## DESIGN REVIEW BOARD DECISION

**FILE NUMBER:** DRV23-00164  
**PROJECT NAME:** MODERA BRIDLE TRAILS  
**APPLICANT:** AMANDA KEATING WITH WEBER THOMPSON  
**PROJECT PLANNER:** TONY LEAVITT

# MODERA BRIDLE TRAILS – DESIGN RESPONSE CONFERENCE 2

# AMPLIFY BRIDLE TRAILS CHARACTER: BOARD GUIDANCE (DRB RESPONSE 1)

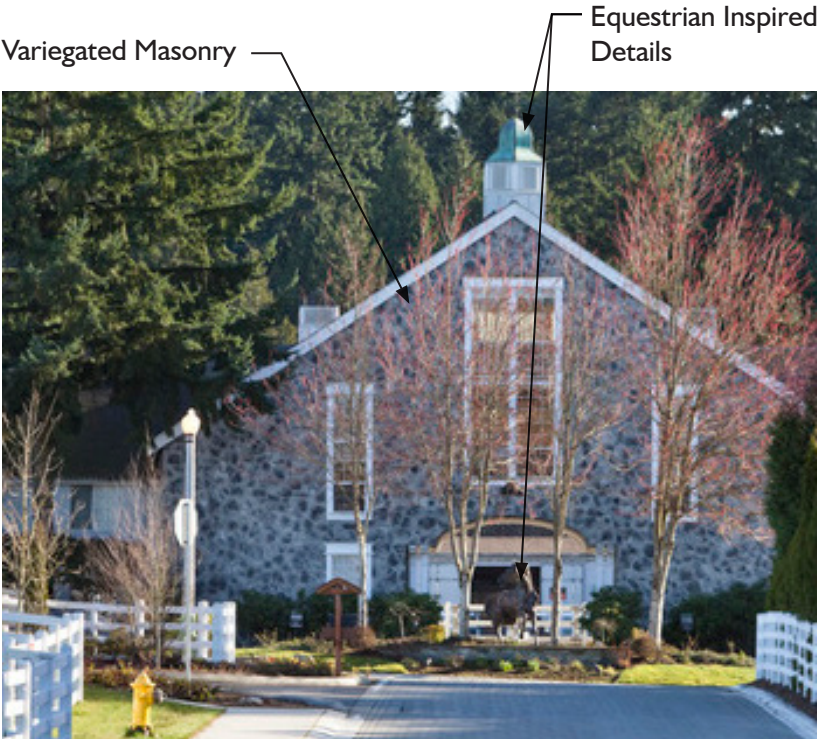
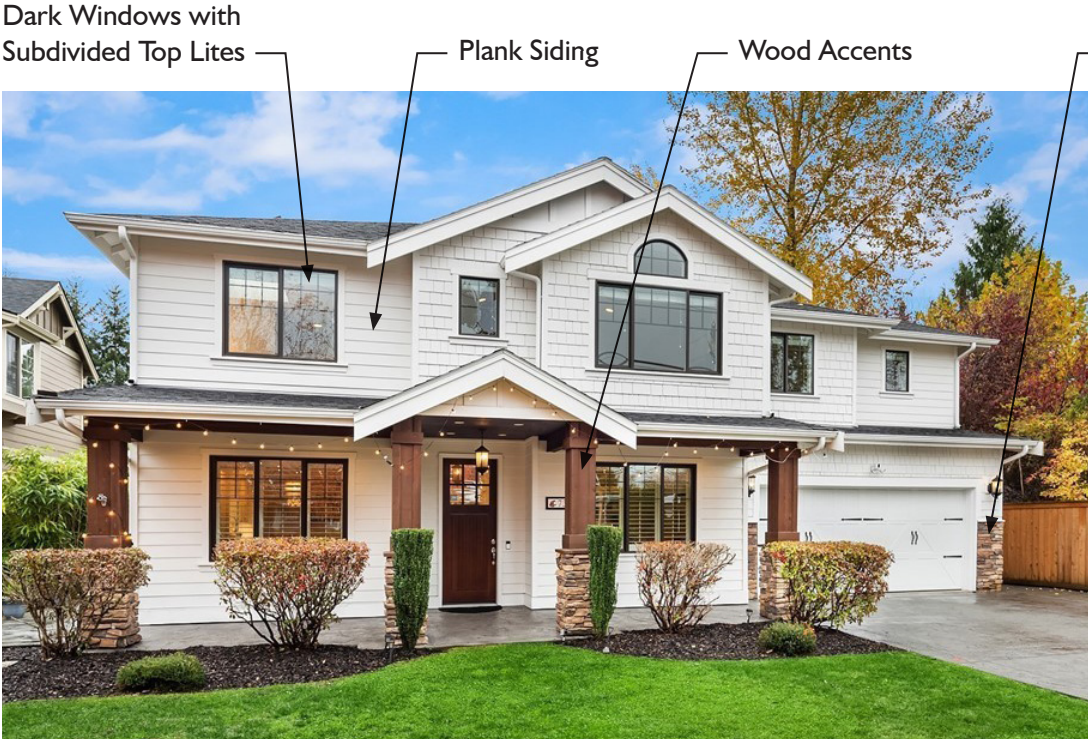
The Design Review Board liked the overall direction of the project, but felt the character of the design could be more precisely fine tuned to reflect the Bridle Trails neighborhood. They wanted to understand more about the design inspirations for the project. The Board suggested art as a way to enhance the through-block pathways and add Bridle Trails specific character elements.

**RESPONSE**  
The design uses neutral tones with richer, warm accents pulled from the picturesque neighborhood. Hints of the area’s equestrian heritage can be found in details throughout the clean design. The project seeks to engage passersby on 70th and the through-block pathways with meaningful information and still-life installations celebrating the past, present and future of Bridle Trails.

# REVISE MATERIAL PALETTE: BOARD GUIDANCE (DRB RESPONSE 2)

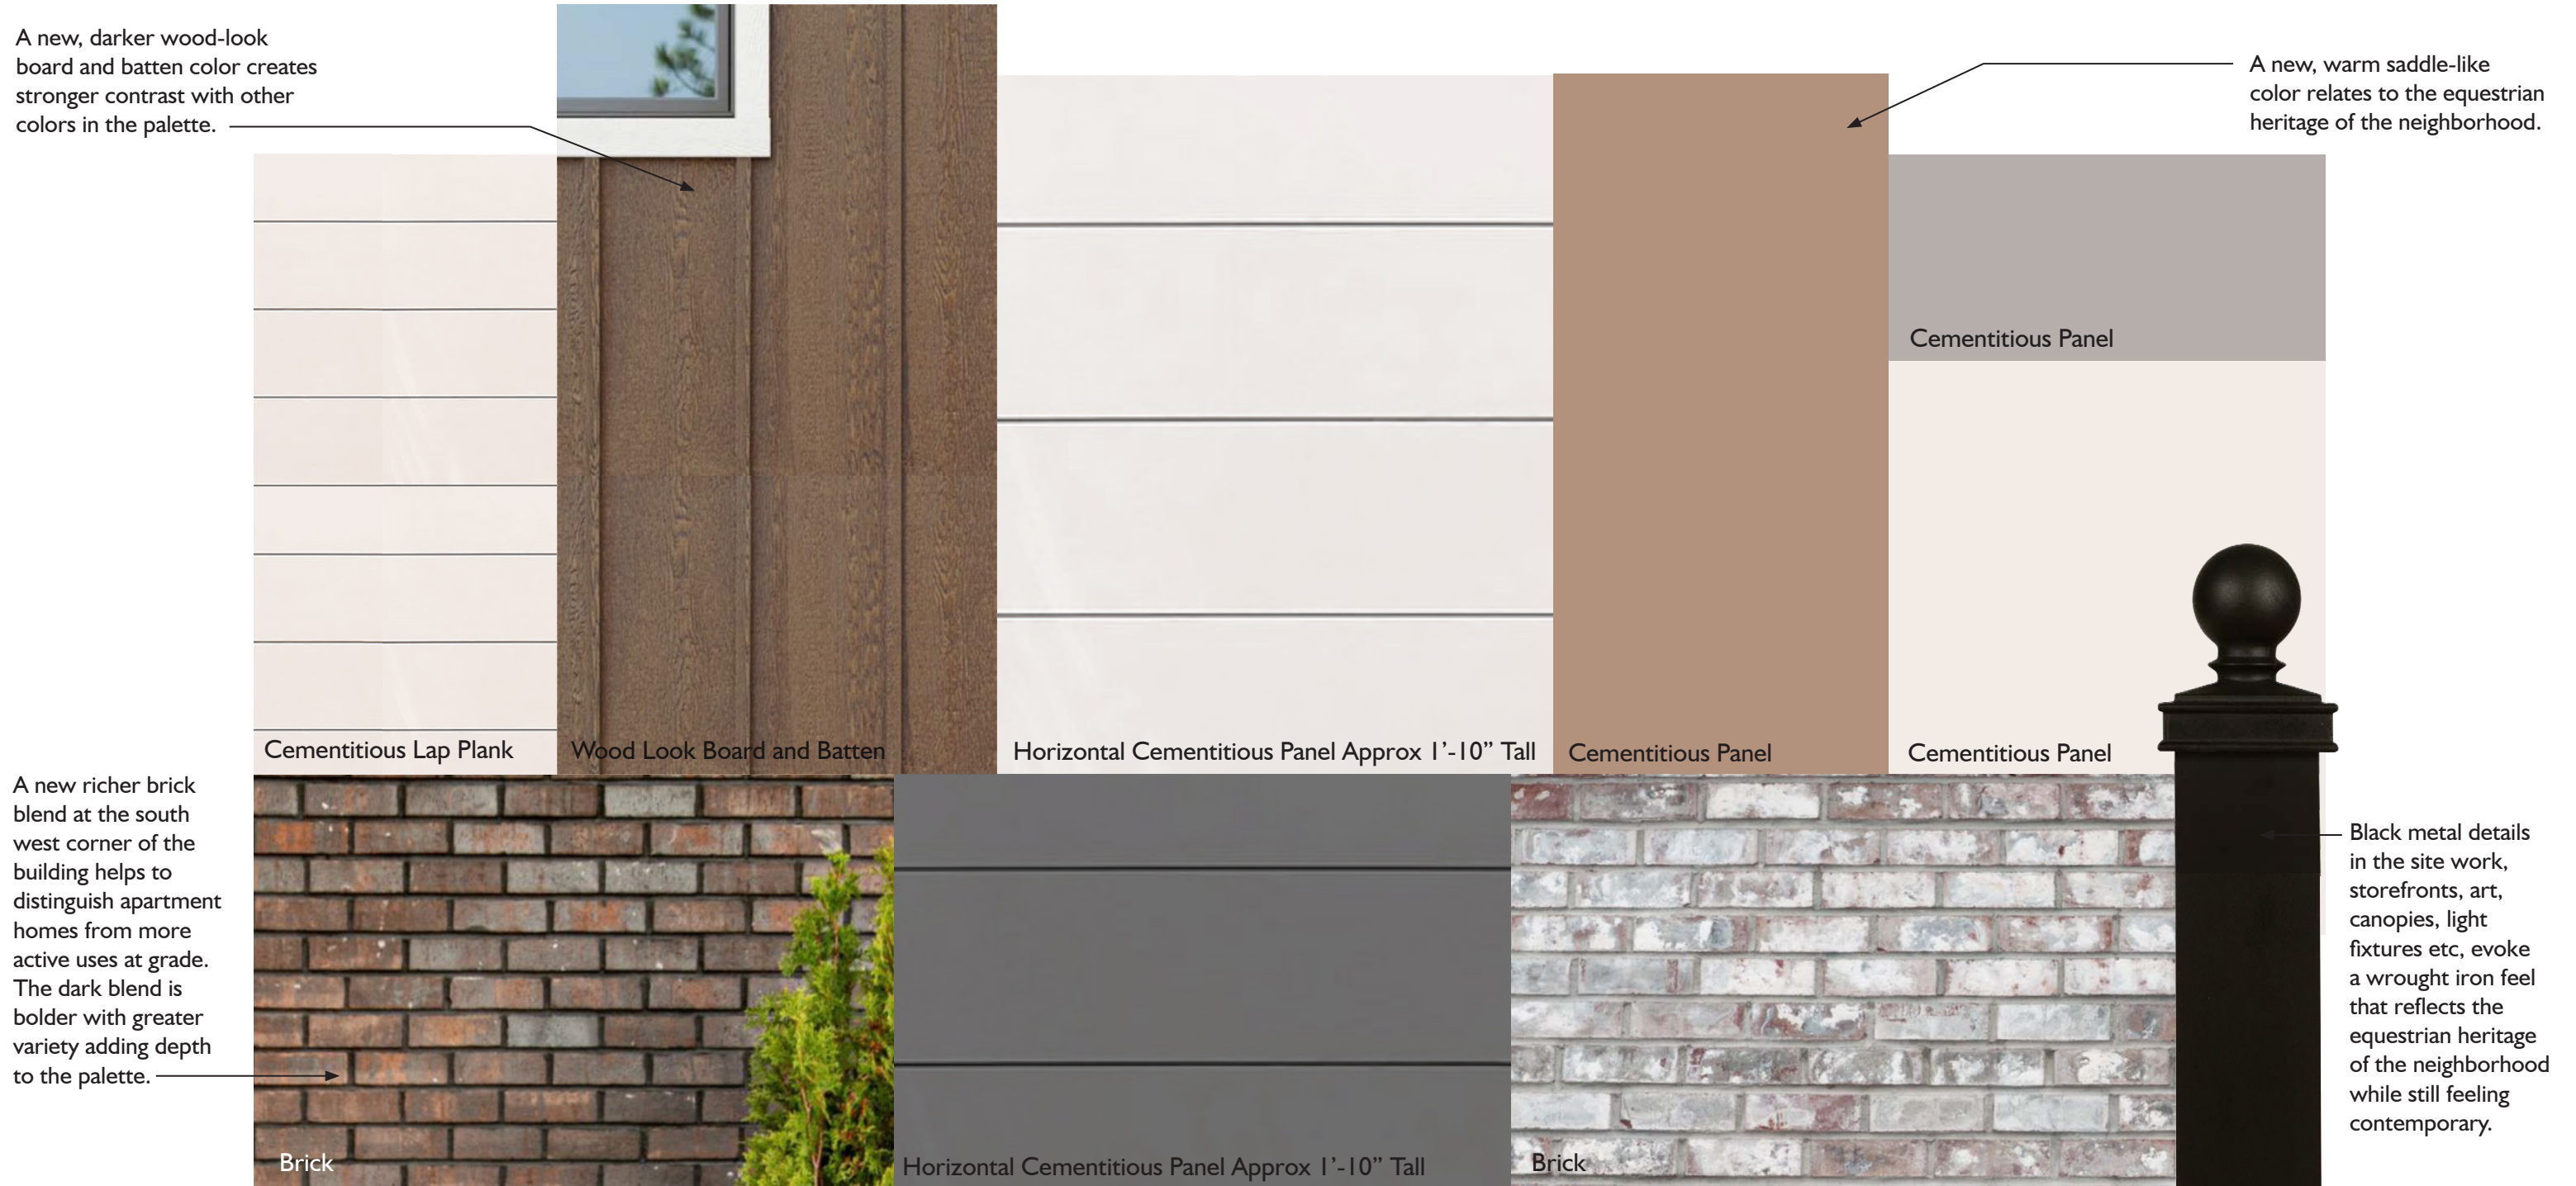
The Board liked the general direction of the materials, but felt the palette was overall too neutral. They wanted to see more depth and richness. They suggested using more than one color for brick.

The updated palette still reflects the sophisticated neutral tones throughout the neighborhood, but makes adjustments for stronger contrast and more warmth. The addition of a second, darker brick blend and a leathery, saddle color add richness and greater variety to the palette.

## RESPONSE 4: PLANT PALETTE DETAIL

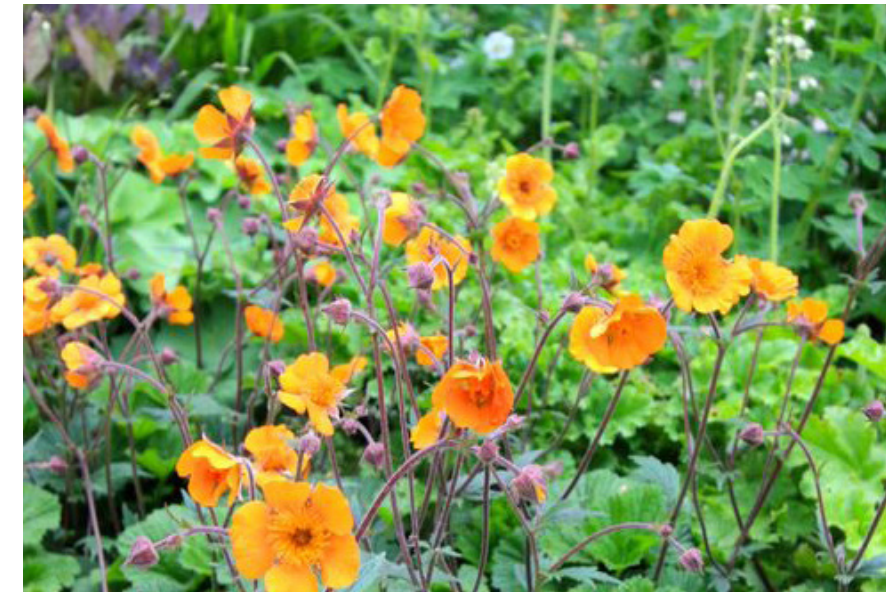
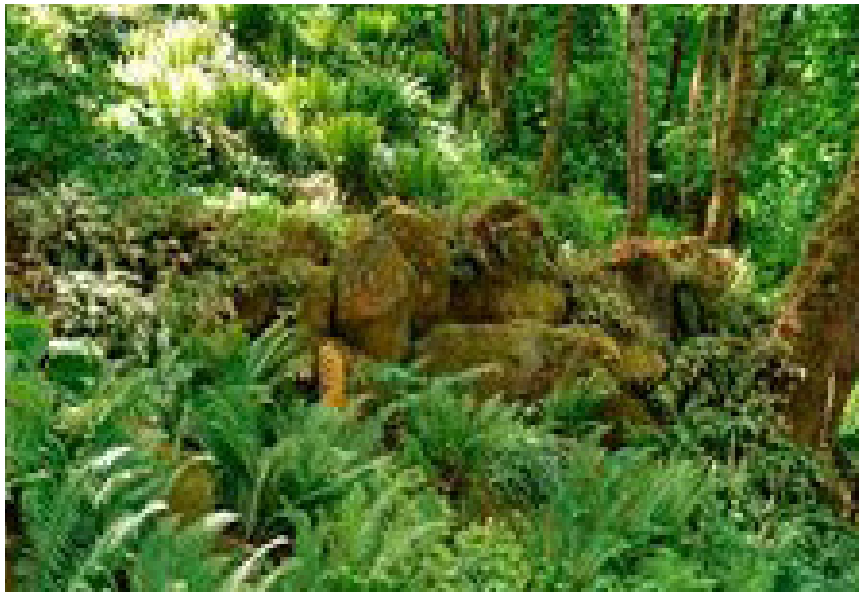
The Board requested more detailed and specific explanation of intent regarding plant palette and placement.

This planting palette is reflective of the Bridal Trails State Park with an emphasis on **native forest understory and edge plantings**. Salal, sword fern and foam flower, among other natives, create a tapestry of green with sprinklings of color from perennials and grasses. Sunnier spaces are meant to evoke meadows and forest edge habitats. Evergreen plants are emphasized for year-round seasonal interest. Ferns and grasses create a sense of movement and texture and catch the light in shady places. Plants are drought tolerant to reduce water use and maintenance.
